PROJECT# - 2020-004250

CASE# - SI-2021-01836

DEVELOPMENT REVIEW APPLICATION

Re: REVISION TO SITE AMENDMENT REQUEST

SITE PLAN FOR **ADMINISTRATIVE AMENDMENT**

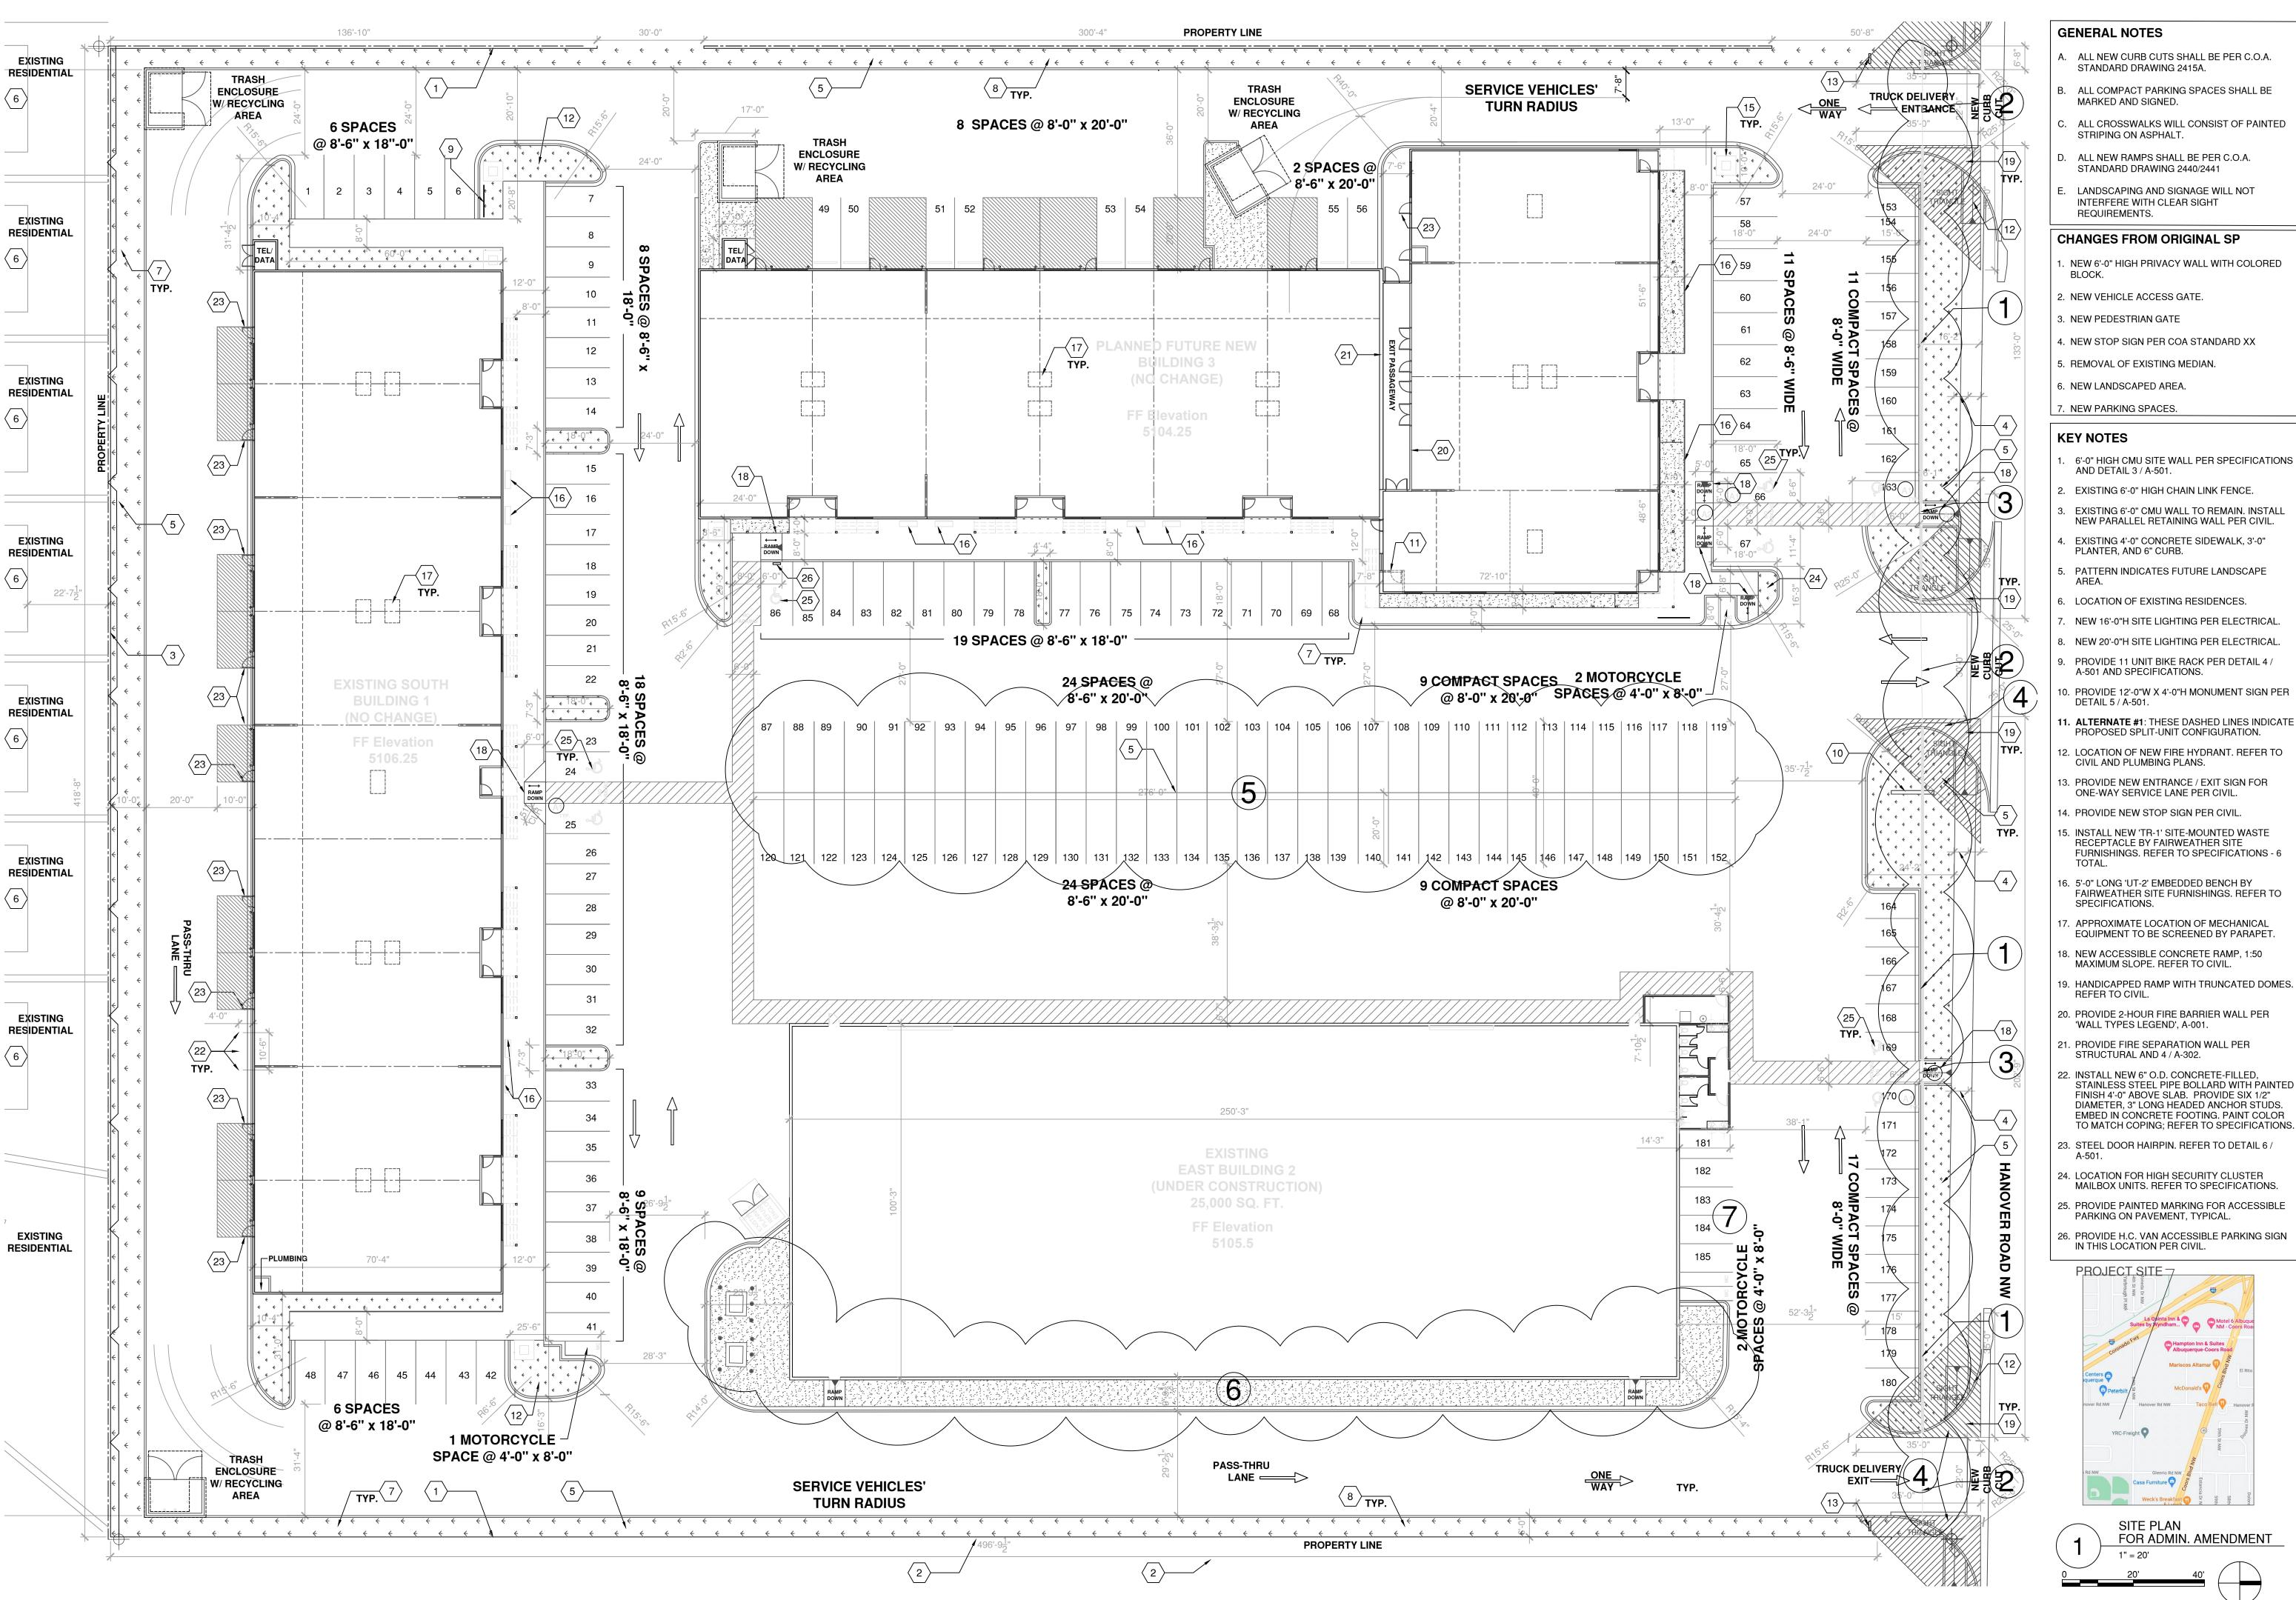
CHANGES FROM ORIGINAL SP

- NEW 6'-0" HIGH PRIVACY WALL WITH COLORED
- 2. NEW VEHICLE ACCESS GATE.
- 4. NEW STOP SIGN PER COA STANDARD XX
- 5. REMOVAL OF EXISTING MEDIAN.
- 6. NEW LANDSCAPED AREA.
- NEW PARKING SPACES.

I have done my review, and discovered a variance will be needed.

Per IDO 5-7(D) Table 5-7-1: Maximum Wall Height- Standard wall height in the front yard or street side yard for Mixed-use zones is 3'-0".

Per IDO 14-16-6-4(Z)(1) the proposed wall height of 6'-0" breaks the minor amendment threshold by requiring a variance.

Please indicate which direction you would like to take:

Option 1: Adhere to the 3' maximum height standard, and the AA review will continue.

Option 2: Apply for a variance for the 6'-0" Privacy fence and then re-apply for an AA.
